Document Reference: EP23-095(08)—011A

11 October 2024

Attention: Craig Graham
Okeland Communities

BULLSBROOK LANDHOLDING LOCAL WATER MANAGEMENT STRATEGY ADDENDUM

Figure 2: Stormwater Management Plan

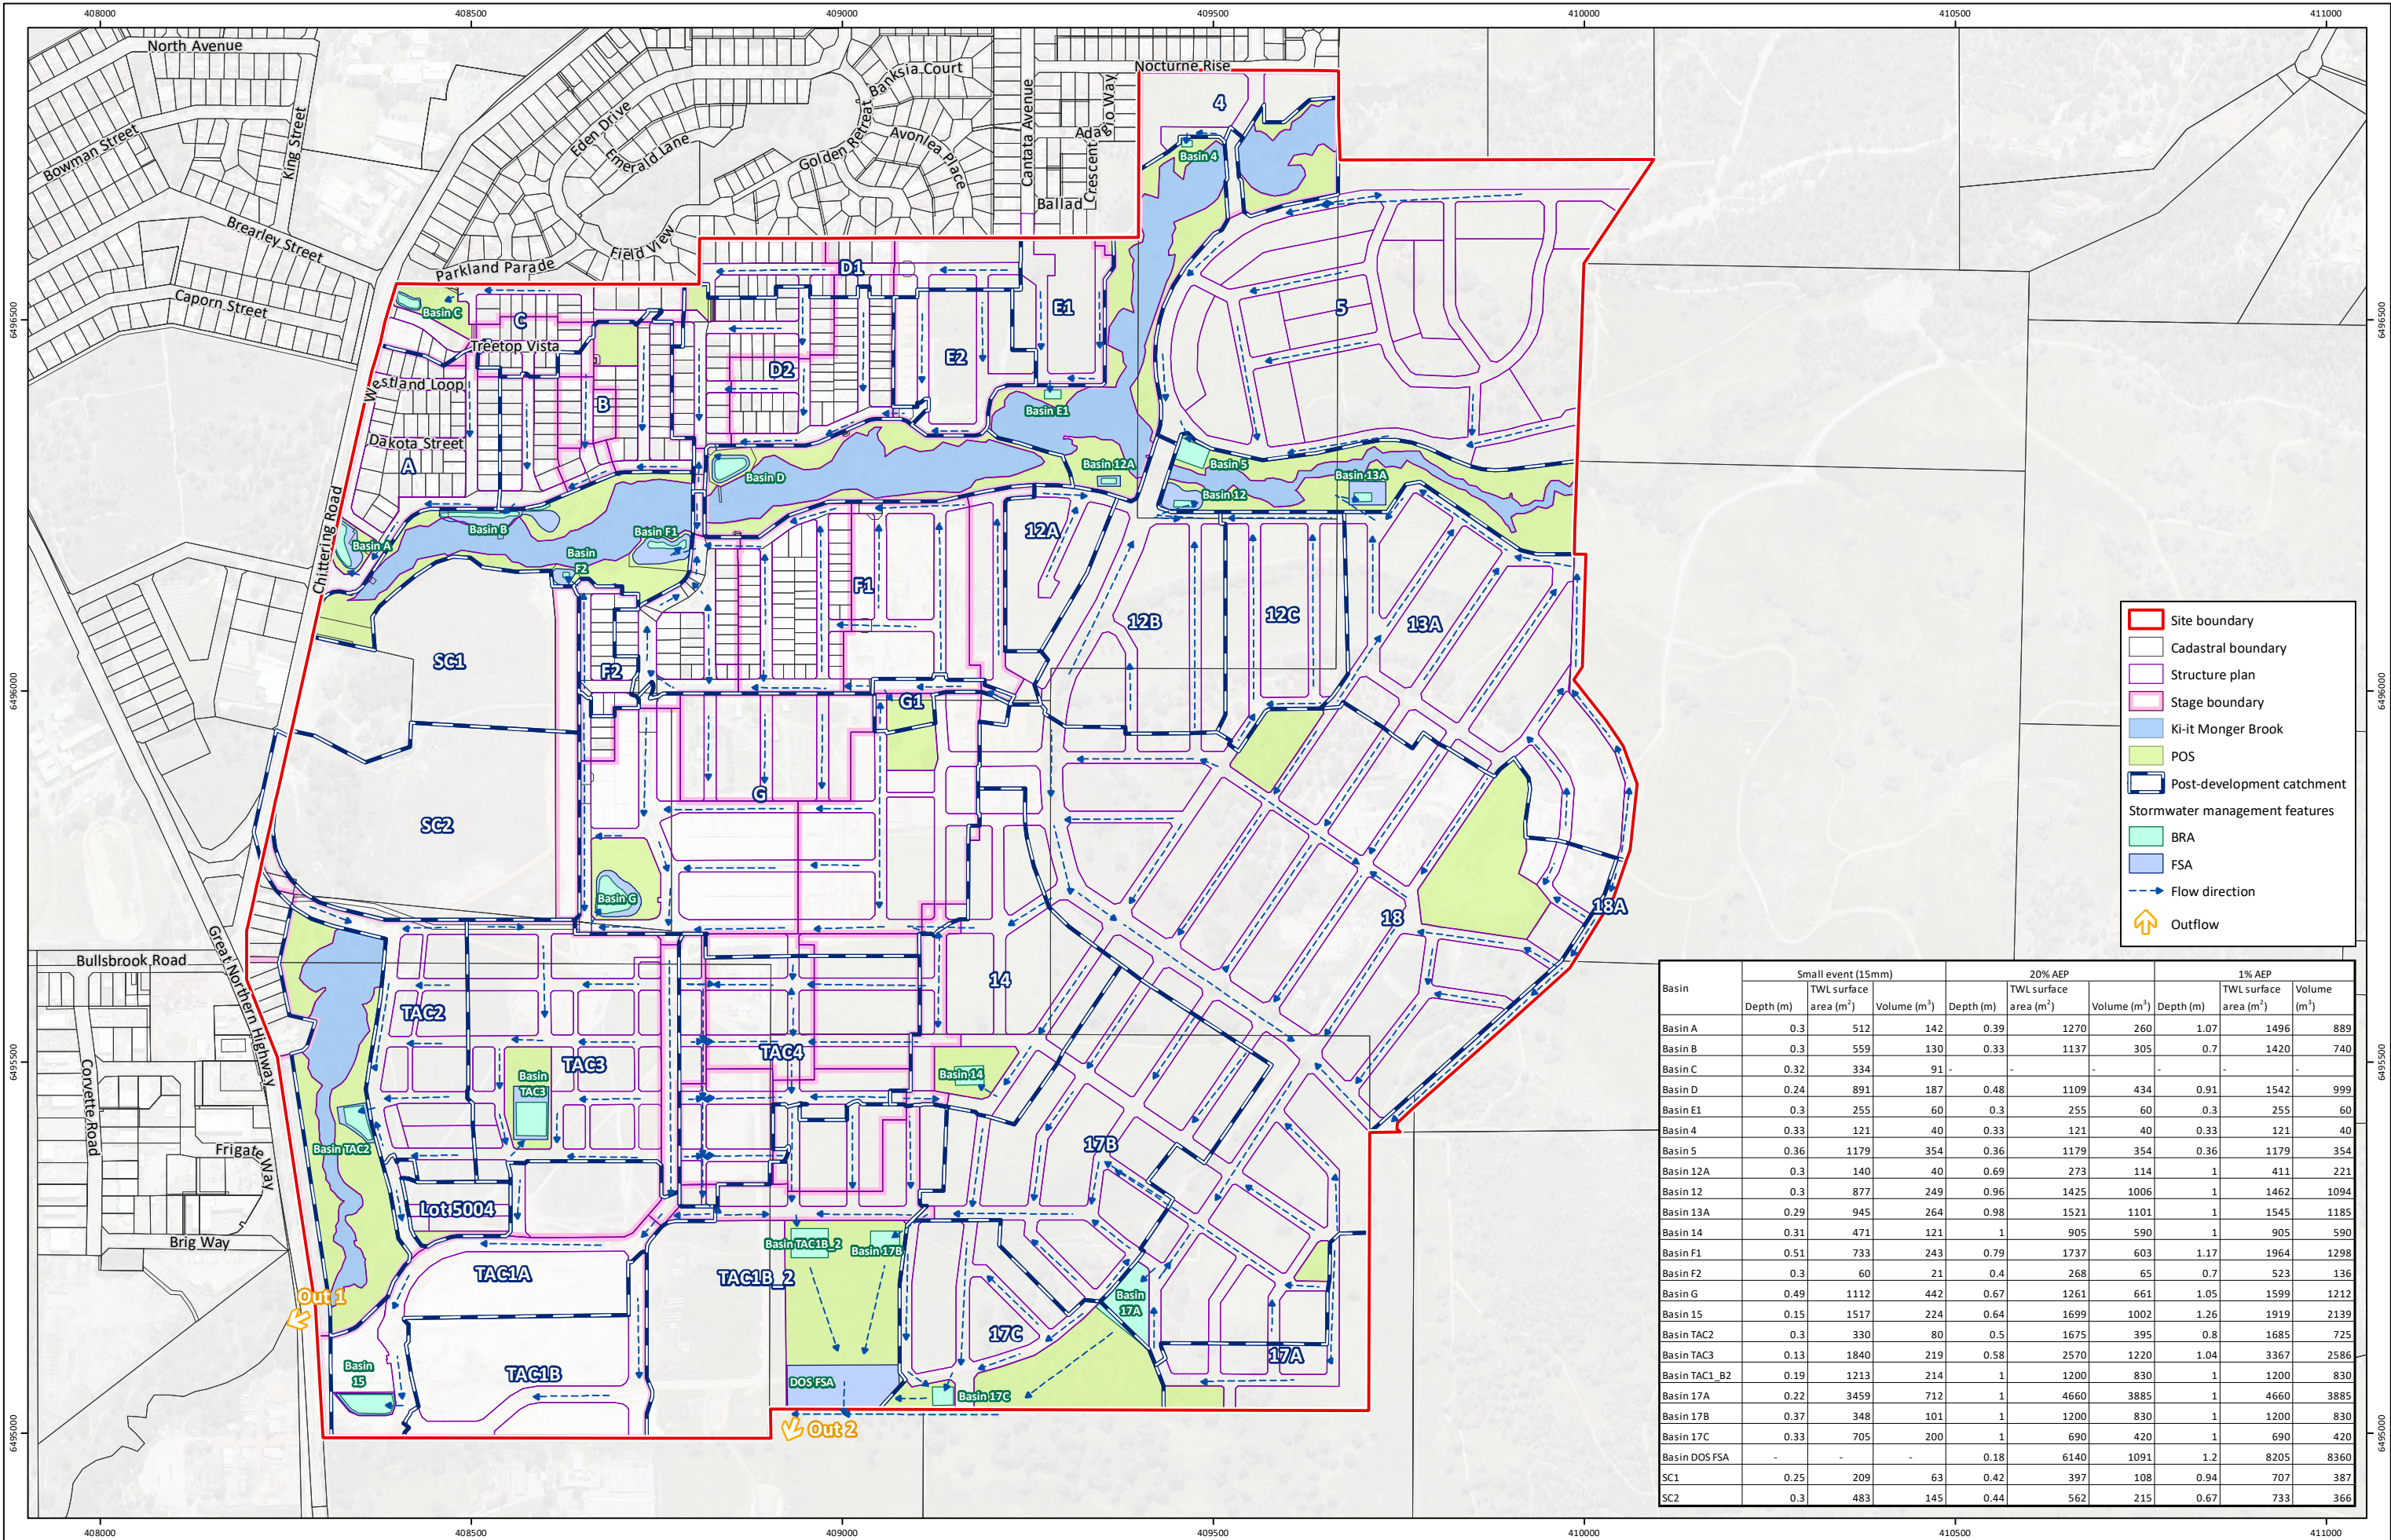
Summary of changes from approved LWMS

The main changes that have occurred since approval of the LWMS (RPS 2018) include:

- The road and lot layout has evolved to suit changes to design stages, lot product mix and POS locations.
- The approach to earthworks is to import 1.3 - 1.5 m of fill to achieve final lot levels, and this facilitates a greater level of at-lot storage of rainfall.
- Outflow to the south of the site and towards Nambad Brook is proposed to be maintained rather than redirected to Ki-it Monger Brook (which resulted in larger piped drains and changes to the site hydrology).

- Ki-it Monger Brook leaves the site through culverts under Great Northern Highway south-west of the site, at a rate 11.82 m³/s shown as Out 1 in **Figure 2**. This conveys the majority of runoff from the site.
- Runoff from the eastern part of the site as well as the upstream catchment to the east of the site discharges via a small streamline to the south at a rate of 1.37 m³/s, shown as Out 2 in **Figure 2**. Runoff from this location eventually enters Nambad Brook south of the site.

Discharging at both Out 1 and Out 2 (rather than at Out 1 only as proposed in the approved LWMS (RPS 2018)) will ensure that the pre-development hydrological regime is maintained.

The stormwater management strategy proposes to maintain pre-development hydrological regime of Ki-it Monger Brook by conveying inflow from upstream catchments and tributaries through the existing channels and dam to protect downstream areas from flooding. Ki-it Monger Brook will discharge from the site through the existing culverts at pre-development rates.

Inflow from upstream catchments east of the site will be conveyed through the site, via a pipe or overland pathway, and discharged via the existing streamline to the south of the site at pre-development rates.
